- 9. Tulin Birch Lake Subdivision; KPB File 2023-011
Segesser Surveys / Alaska Growth Properties, LLC
Location: Rector Street
Nikiski Area / Nikiski APC**

**ITEM #9 - PRELIMINARY PLAT
Tulin Birch Lake Subdivision**

KPB File No.	2023-011
Plat Committee Meeting:	December 11, 2023
Applicant / Owner:	Alaska Growth Properties, LLC located in Anchorage
Surveyor:	John Segesser / Segesser Surveys
General Location:	Rector Street in Nikiski

STAFF REPORT

Vicinity Map

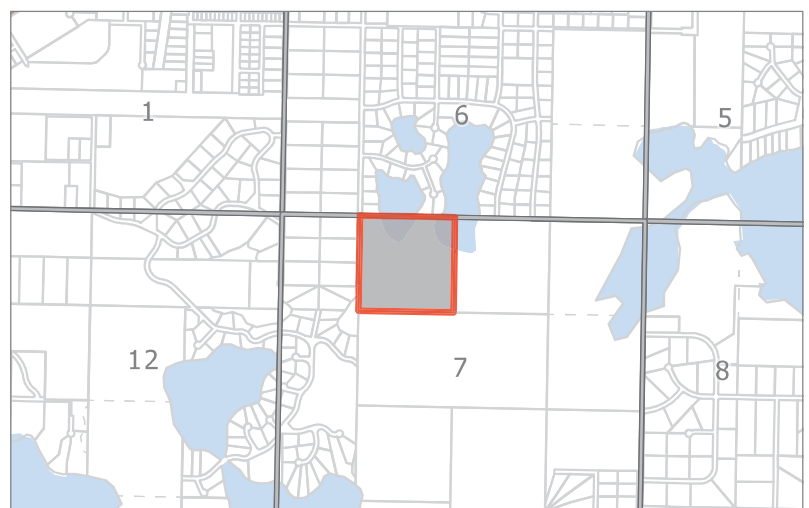
Vicinity map should square out Lot 3 being the subdivision but not the lake area portion.

Label and show Rector Street site and identify Birch Lake. Show roads out to Kenai Spur Highway but don't label.

11/07/2023

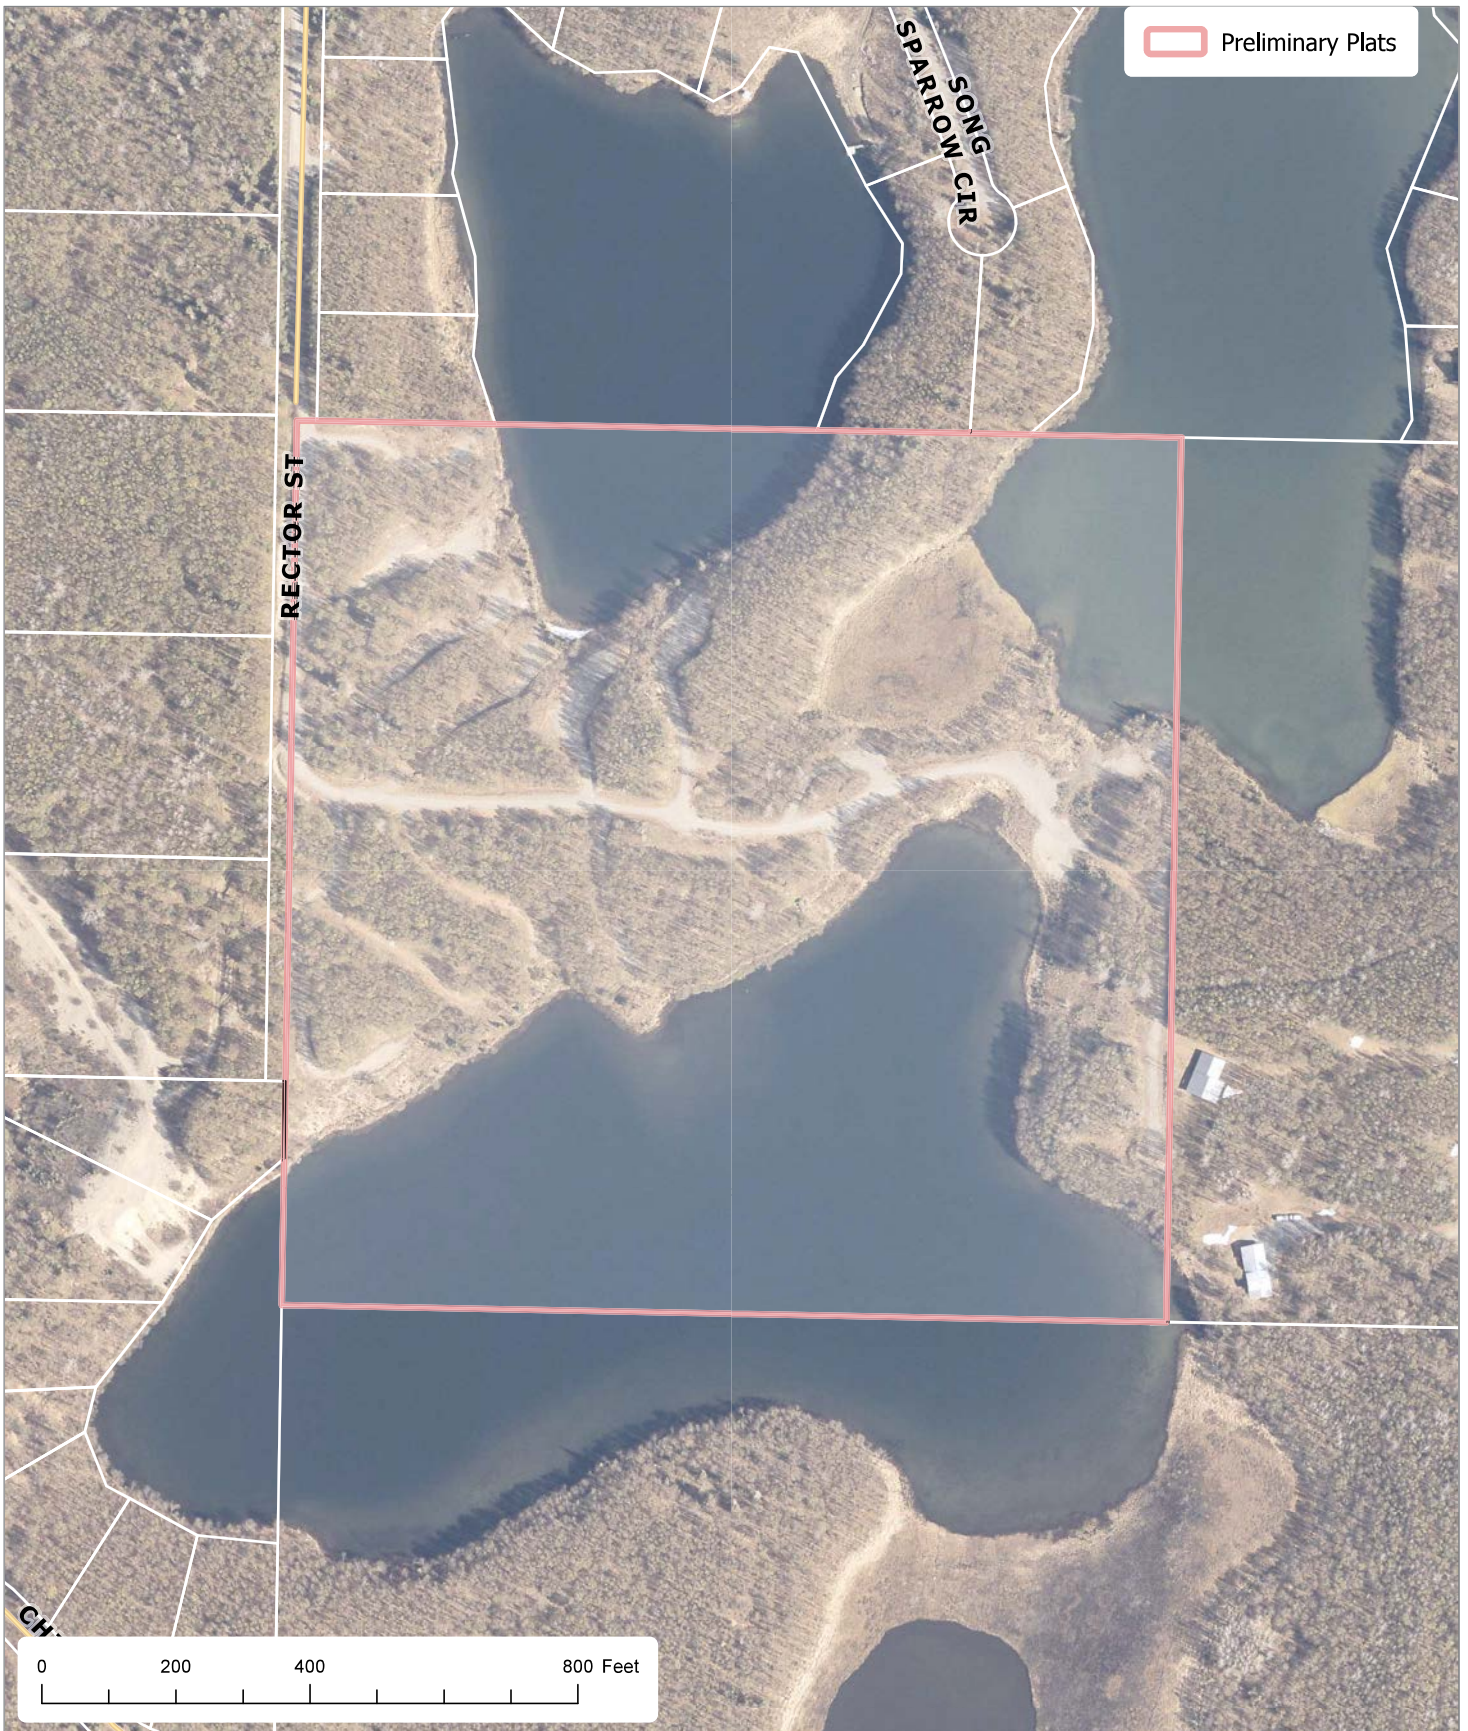
The subdivision is affected by a 33' section line easement across the north line of the subdivision. **Staff recommends:** the surveyor verify the existence and width of the section line easement and show it on the final.

There are steep areas per the KPB GIS information, contours were not given on the drawing. **Staff recommends:** steep areas be shown on the final and plan and profile be submitted along Kipper Avenue to be reviewed by the Roads Department for steep grades in case slope easements are needed.

Wetlands are shown on the plat in Lots 7 & 8, the identifier should be added to the legend. **Staff recommendation:** place a note on the final plat indicating any person developing the property is responsible for obtaining all required local, state, and federal permits, including a U.S. Army Corps of Engineers wetland determination if applicable.

The plat is proposing a 15 foot utility easement along road rights-of-ways and 20 feet within 5 of side lot lines. **Staff recommends:** the surveyor show the easement on the drawing or provide a typical detail.

Add 2023-011 to the KPB File No.

Remove NW1/4 from the legal to match the certificate to plat and deeded description.

Area of land computed is 40.087 ac, please correct to surveyed area for final.

All adjacent lots need to have the plat label added them.

Add "unnamed" to the two lakes on the north.

Add to the legend a label for the wetlands

Contours not shown. GIS data shows areas where grade may be steep, supply plan and profile along road alignments.

No contours given. GIS data shows areas where steep grades look to be over 20%. Top and tow with the label 'steep grade' need to be added to the final

Road is between two lakes along an existing road. 210 feet between lakes per GIS data at the closest point, need better data.

Plat note 5 list Covenants not listed in the Certificate to Plat but recorded for Birch Lake Subdivision. If these are included in the final Certificate to Plat, keep the note on the final, if not included the note should be removed.

Add the date of December 11, 2023 to the Plat Approval.

Add Certificate of Acceptance.

Add manager behind Don Tulin's name under the signature line in the Certificate of Ownership and Dedication.
